AGENDA
Village of Chenequa
Monday, December 9, 2024
31275 W County Road K, Chenequa, WI 53029

STAFF REVIEW

Subject: Site Plan Review

Project Description: Proposed Single-family Dwelling and Landscape Plan

L-7.00

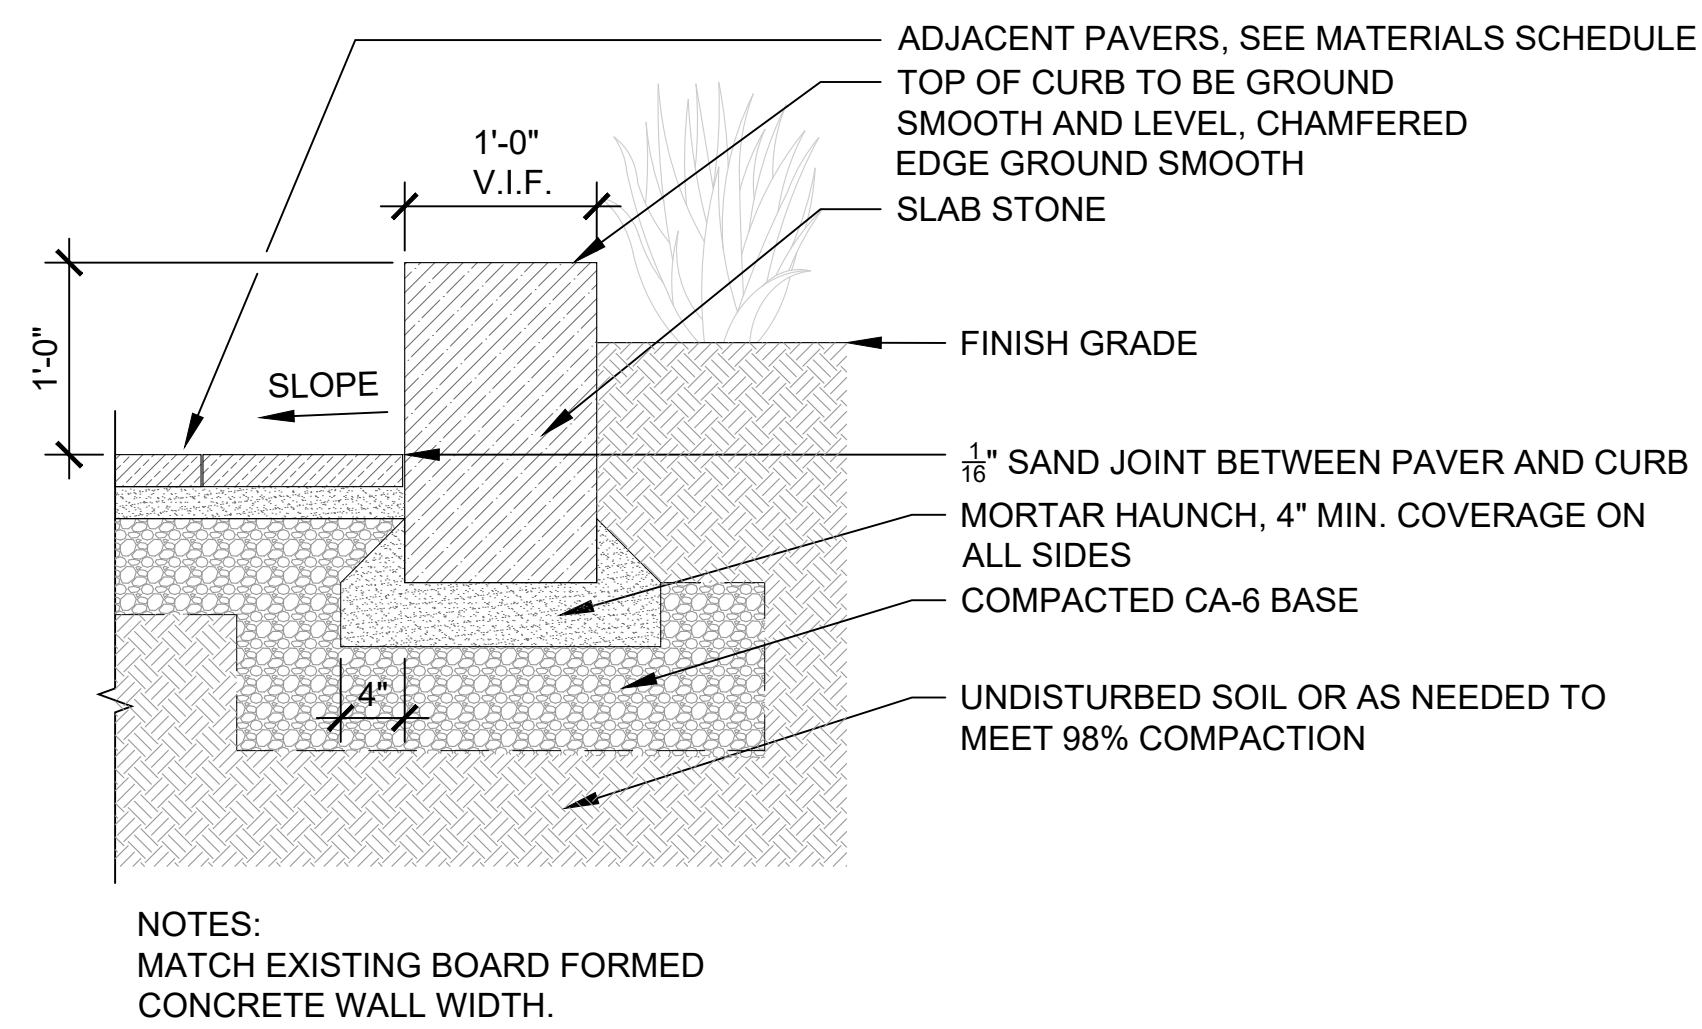
- a. A detail of this proposed reworking can be found on L7.10 of the provided plans.
- b. As depicted, there will be a 1' tall X 1' wide portion of curb added near the end of the walkway.
- c. Both entries to the home will be paved with granite pavers as shown in plans
- d. The main entrance is within the 75' setback of the OHWM

Previously Approved Grading Plan

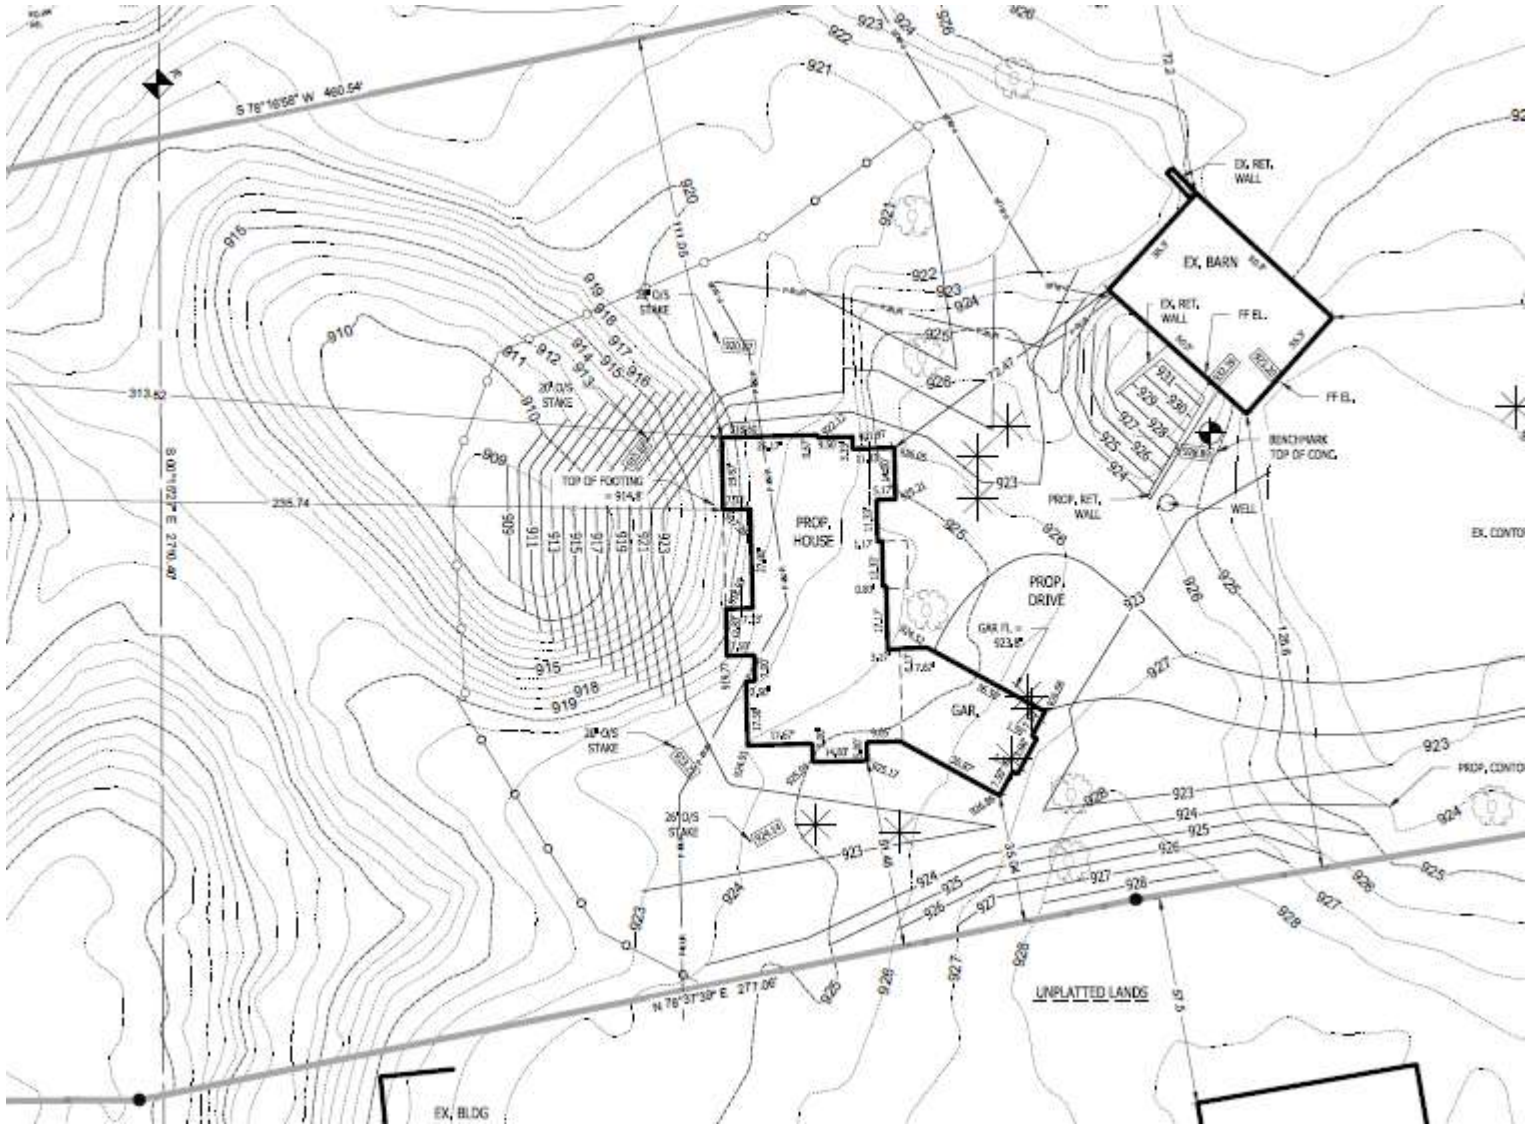
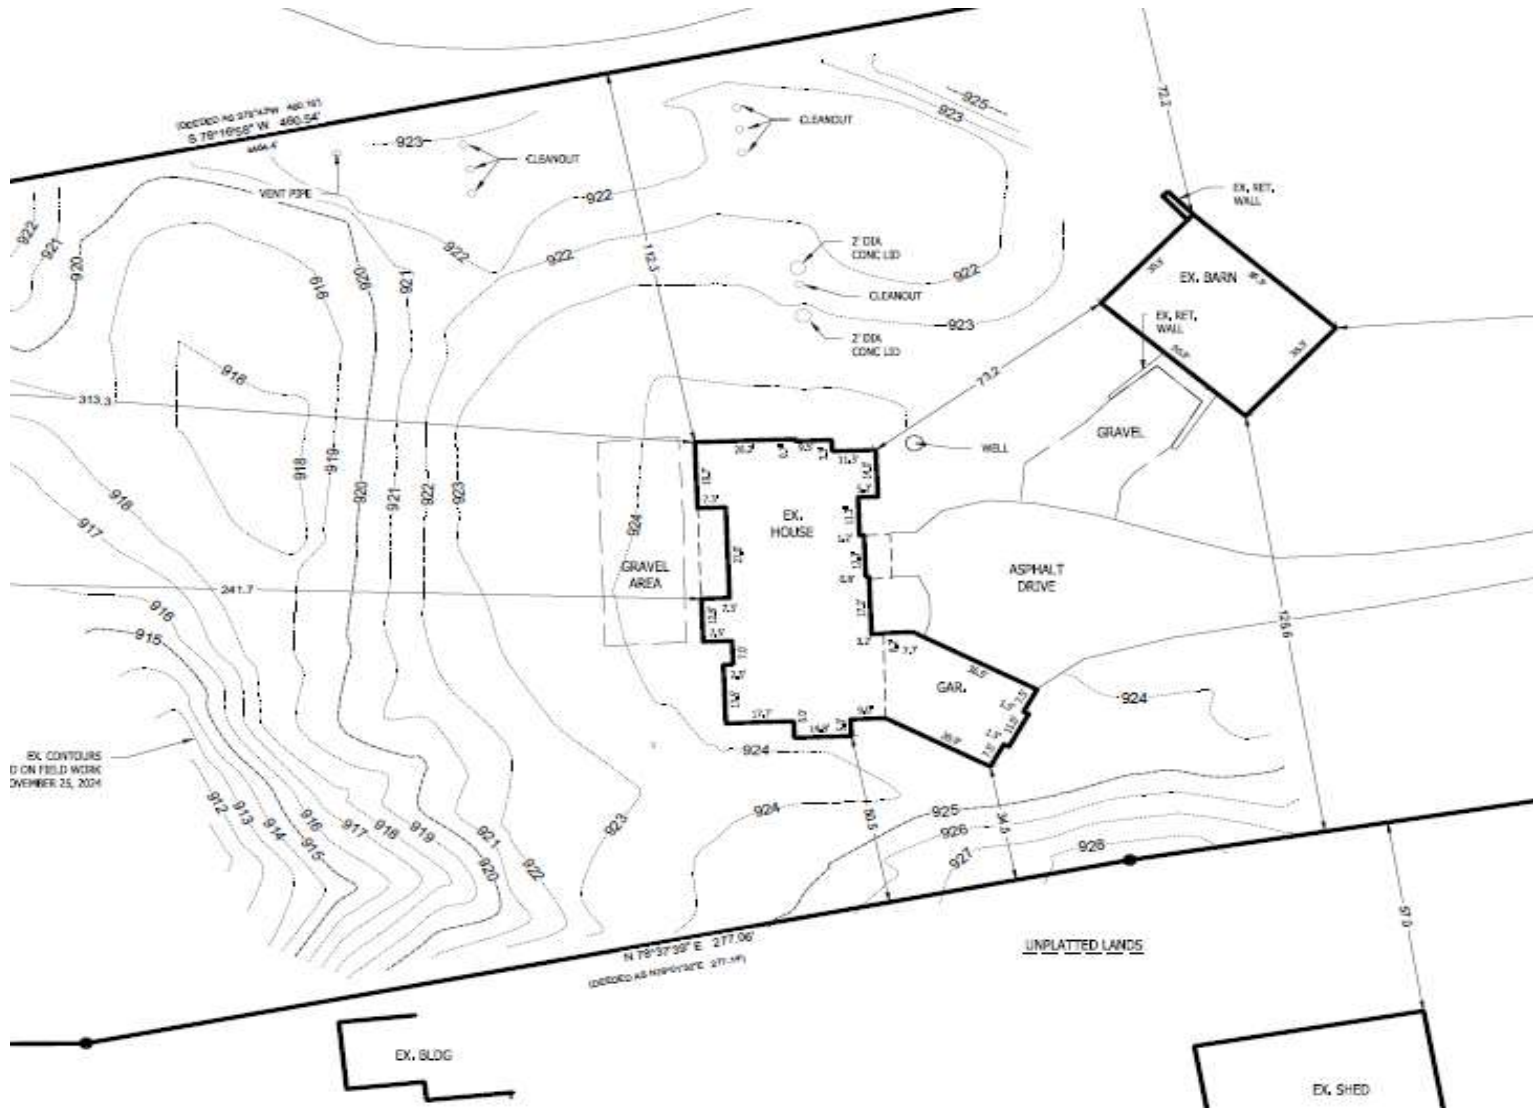
In March of 2023, Kent and Renee Haefs received approval from the Village board for the construction of a primary residence at 4779 N Pine Meadows Lane. Included with the house plans were the grading plans that were also approved. Recent grading on the property has deviated from the previously approved grading plan. As a result, the applicant is resubmitting a grading plan that reflects the grading work that was completed on the property.

Portions of the grading activity involved the partial filling of a depression in front of the house. This land disturbance activity has resulted in ponding after heavy rain events. If ponding persists after the site has been seeded it is the Villages recommendation to install a stone catch basin or French drain in the bottom of the kettle to help improve stormwater infiltration.

In addition to the updated grading plan, the applicant is also seeking permission to install a concrete patio that is 18' X 50' (Approximately 900 square feet). This patio is 150'+ from the ordinary high-water mark of Pine Lake.

A copy of what was previously approved and what requires approval has been included in the packet.
